LAND-ROVER SERVICE NEWS LETTER
No. 26

September, 1962

Item 132 SUBJECT: CLUTCH MECHANISM

MODIFICATION: Introduction of hydrostatic clutch, that is, clutch mechanism which requires no adjustment for the life of the clutch plate.

Fig. 1. Early type clutch mechanism

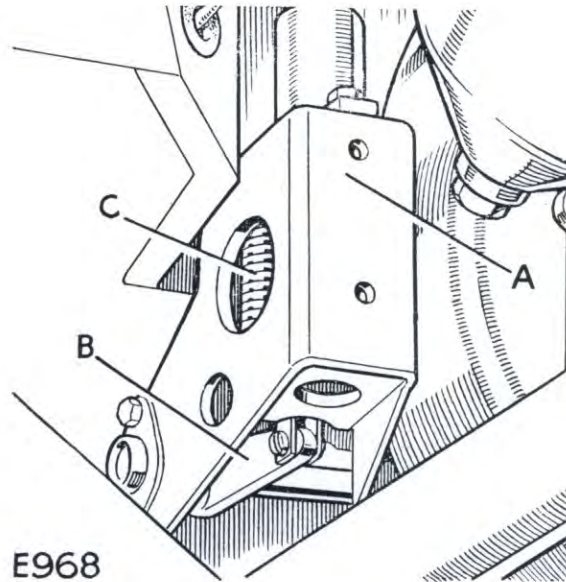
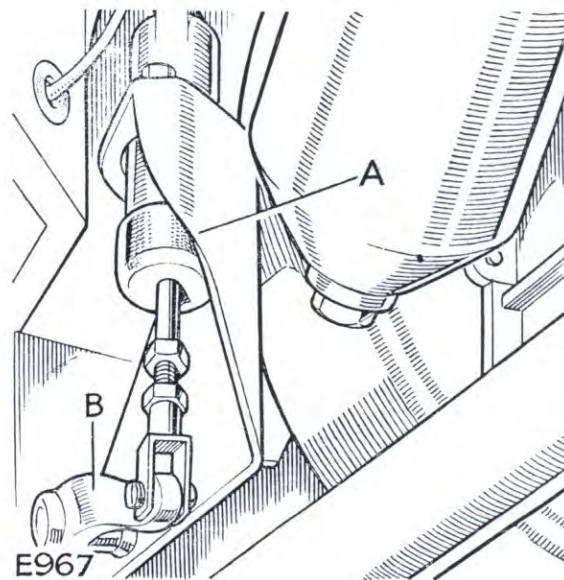
Models with the latest type clutch mechanism can be easily identified as follows:

- (a) The support bracket for clutch slave cylinder on early models encloses the cylinder; on late models the cylinder is exposed.
- (b) The operating lever on early models is straight, but on late models it is cranked.
- (c) Return spring is not fitted to the operating lever on late models.

All these differences are clearly shown at Figs. 1 and 2.

Fig. 3. Setting hydrostatic clutch linkage, Method A

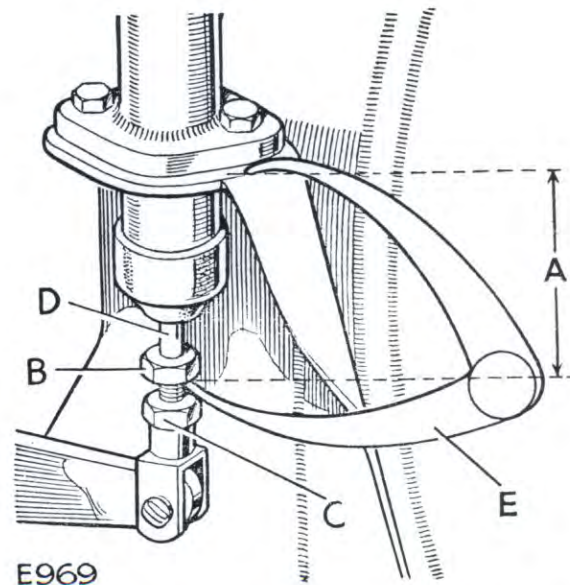
3. Therefore, should a new clutch plate have been fitted, or a clutch assembly, clutch pressure plate, clutch slave cylinder, support bracket for cylinder or flywheel have been removed and replaced, it becomes necessary to re-set the free movement at the pedal pad as follows:

- (a) If necessary bleed system, then hold operating lever on the clutch cross-shaft down and ensure there is no free movement or backlash in the clutch withdrawal mechanism.

- (b) Adjust the push rod if necessary by slackening off lock nut 'C', and rotating push rod with the fingers to give dimension 'A' as shown as Fig. 3. Do not adjust nut 'B' to obtain this figure. Nut 'B' must always be tightened to the end of the push rod thread.

A— $1\frac{7}{8}$ in. (48 mm)

B—Nut must always be at end of push rod thread

C—Lock nut for push rod

D—Check dimension with calipers as shown

Early Land-Rover Series II and IIA models can be modified by fitting the new parts detailed above, discarding the return spring for operating lever and adjusting the push rod as shown at Fig. 3.

Fig. 4. Setting hydrostatic clutch, Method B

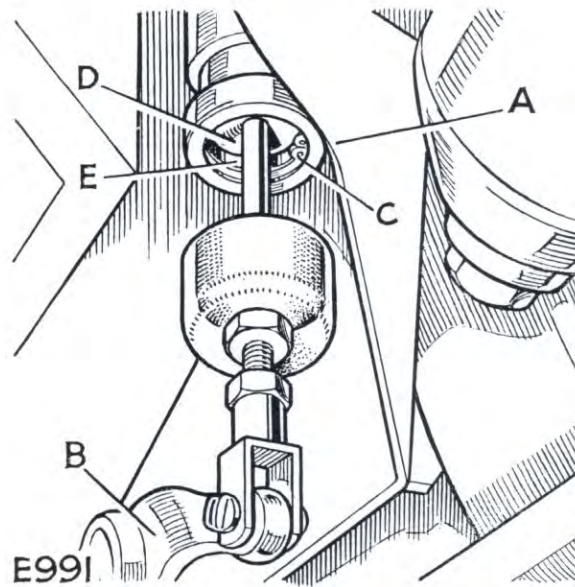
- (c) Fully depress clutch pedal and withdraw rubber boot on cylinder. Then adjust push rod until there is approximately $\frac{1}{8}$ in. (3 mm) clearance between bottom of piston and circlip. See Fig. 4.

A—Exposed slave cylinder
 B—Cranked operating rod
 C—Circlip
 D—Piston
 E— $\frac{1}{8}$ in. (3 mm)
